COMMUNITY DEVELOPMENT DEPARTMENT REPORT

HEARING 8/18/2026

SUBJECT: Summerlin AZ, PP & MDA

H-2026-0018

E. Preliminary Plat (date: 4/8/2026)

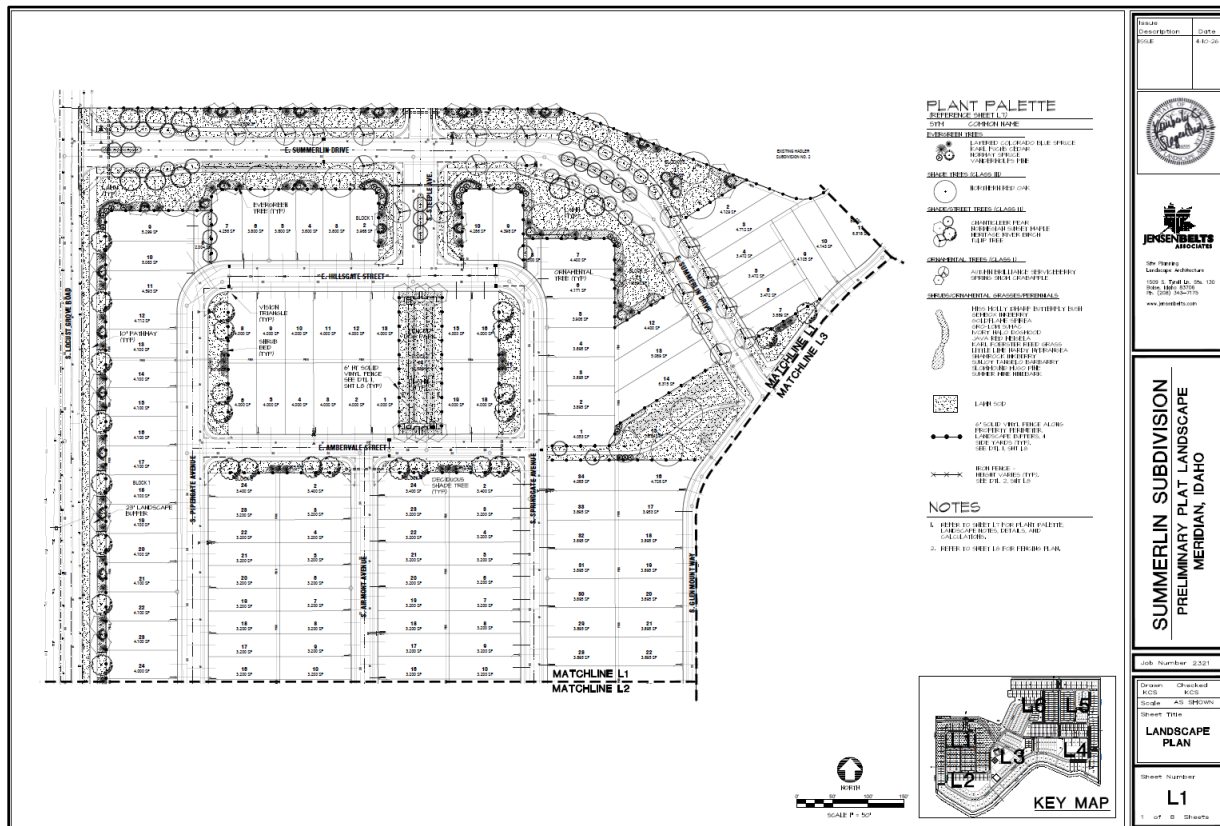
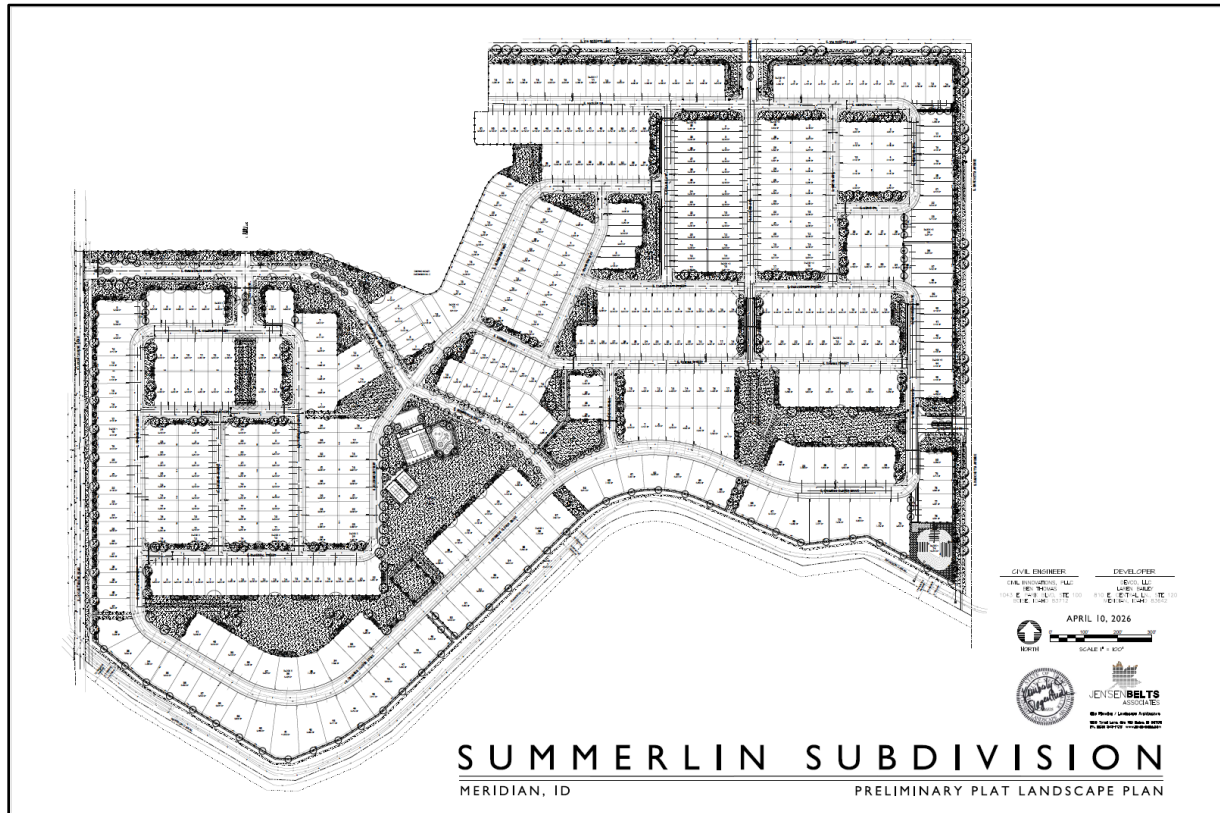
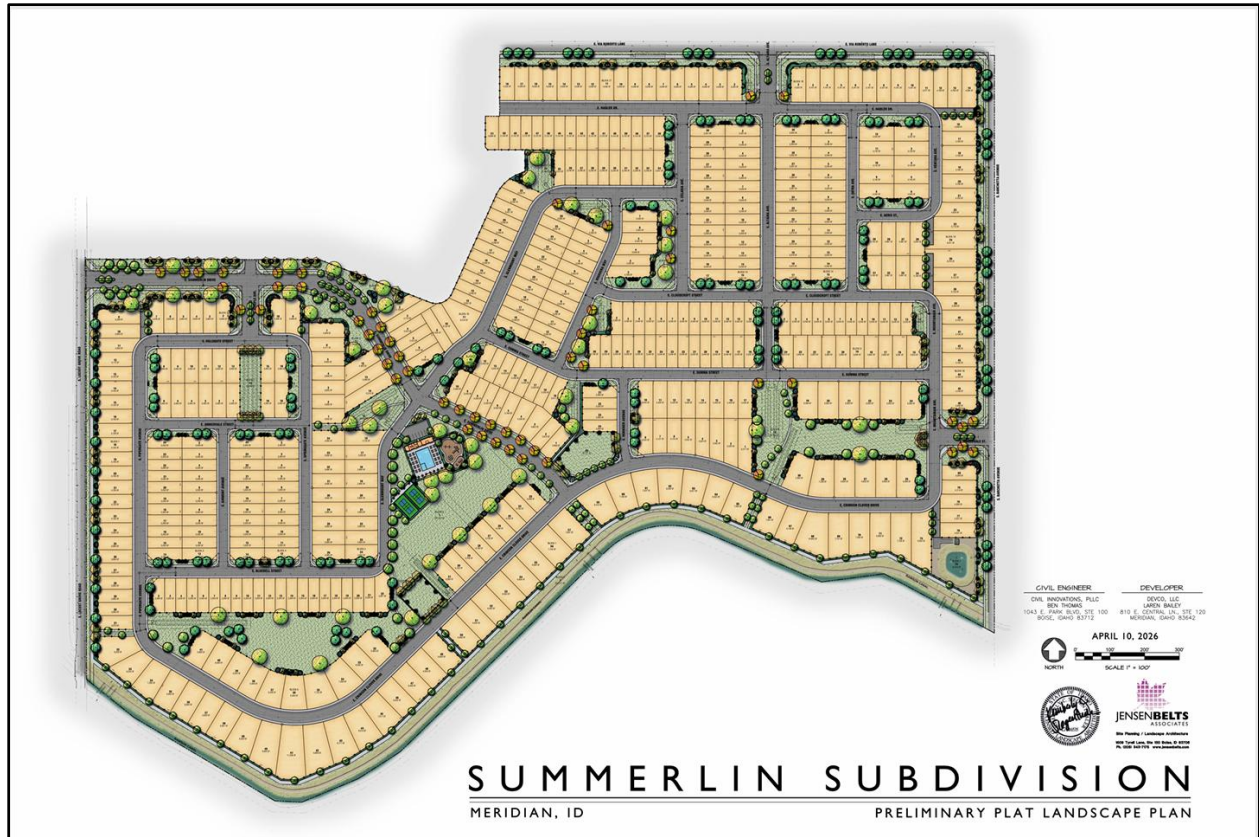
Staff is asking the Commission and Council to weigh in as to whether or not the applicant should revise the plat map to reconfigure Lots 4-7, Block 18 on the northeast side of E. Summerlin Drive so that Lot 9, Block 18 does not have 4 lots backing up to its side yard. Per Comprehensive Plan Policy 3.07.01A, require all new development to create a site design compatible with surrounding uses through buffering, screening, transitional densities, and other best site design practices.

2. The Preliminary Plat included in Section VII, dated 10/10/24, is approved with the following revisions:
 - a. All utility easements reflected on the utility plan shall be included on the final plat.

- b. All pathways and micropathways shall be within a separate common lot or easement as required per UDC 11-3A-8.
 - c. Revise the plat map to reconfigure Lots 4-7, Block 18 on the northeast side of E. Summerlin Drive so that Lot 9, Block 18 does not have 4 lots backing up to its side yard if required by Council.

F. Landscape Plan (date: 4/10/2026)

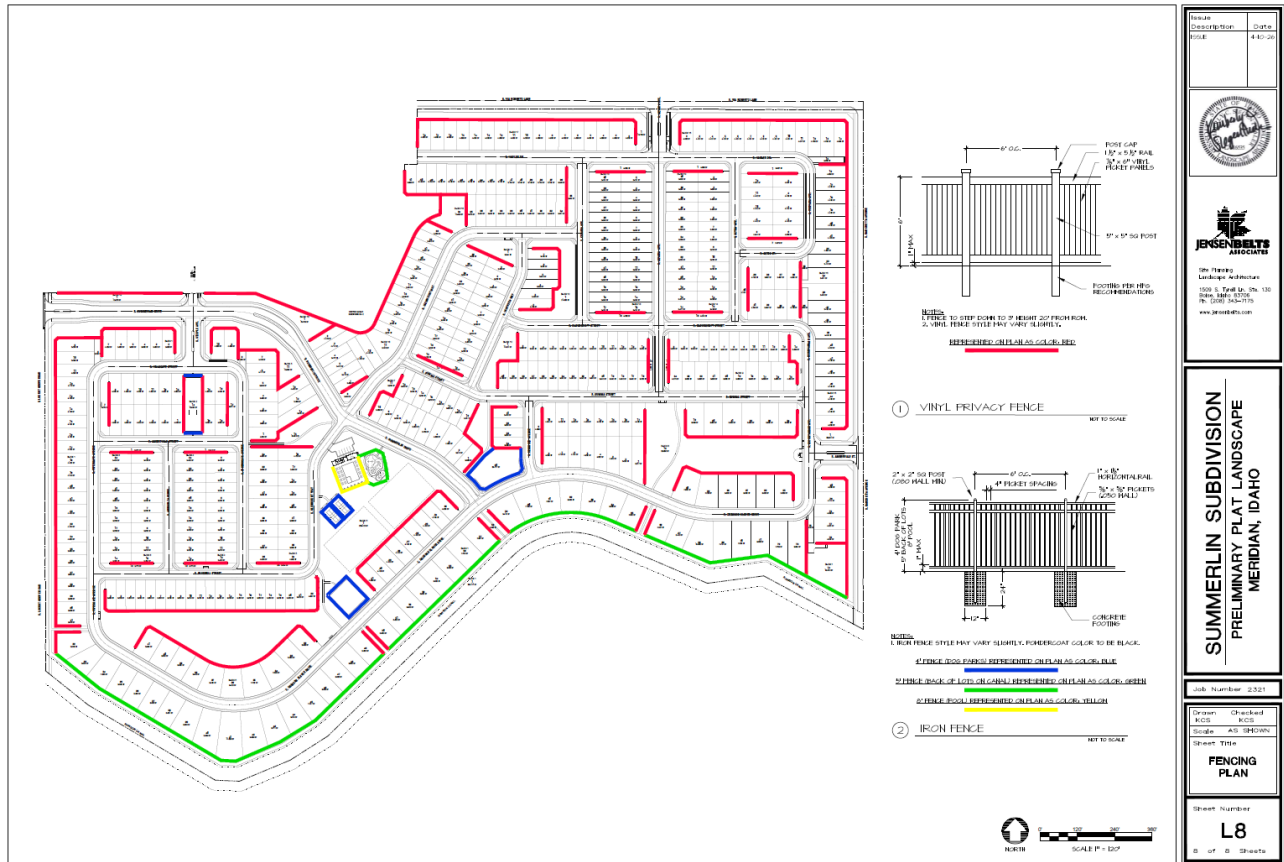
The applicant shall add a mitigation section to the landscape plan for trees meeting the criteria above that are removed.

- a. Show the ten (10) foot wide detached sidewalks along the east side frontage of Locust Grove Road and the west side frontage of S. Recreation Avenue.

- b. Remove a portion of the fence and provide a micro-pathway within Lot 24, Block 18 that connects to the pathway within Hadler No. 3 Subdivision Lot 25, Block 4.

- c. Add pathway landscaping along the south side of the Rawson Canal in accord with UDC 11-3B-12.
 - d. Add shrubs/ornamental grasses/perennials to the pathway within Lot 15, Block 5 and Lot 18, Block 8.
